SEASTAR™
BAYSTAR™

INCREASED TORQUE VALUE FOR POSITIONAL O-RING FITTINGS

Installed on NEW –3 model steering cylinders

Figure A.

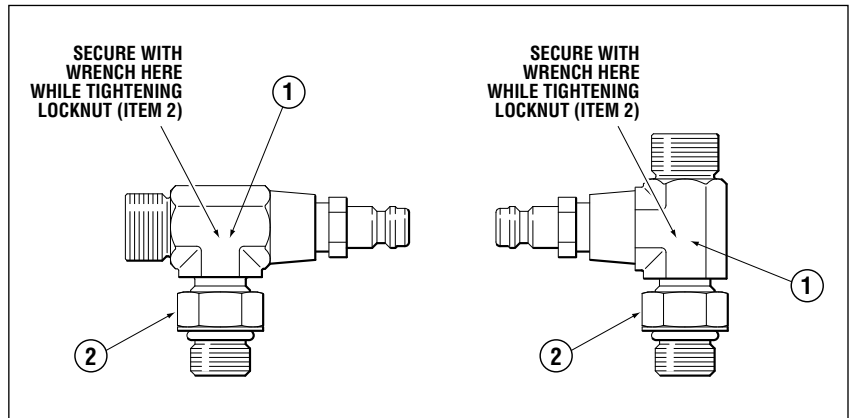
SeaStar Solutions has increased the torque setting of the 'Positional O-ring hose fittings' which are installed in the new –3 steering cylinders. We have found that installations where hoses are; pulling on the fittings during operation, or in an area where they can be stepped on or kinked, over time may lead to loosening of the hose fitting resulting in loss of steering fluid. See list showing the cylinders affected.

While holding fitting body (item 1) with a wrench, tighten the locknut (item 2) and torque to 40–43 ft-lb.
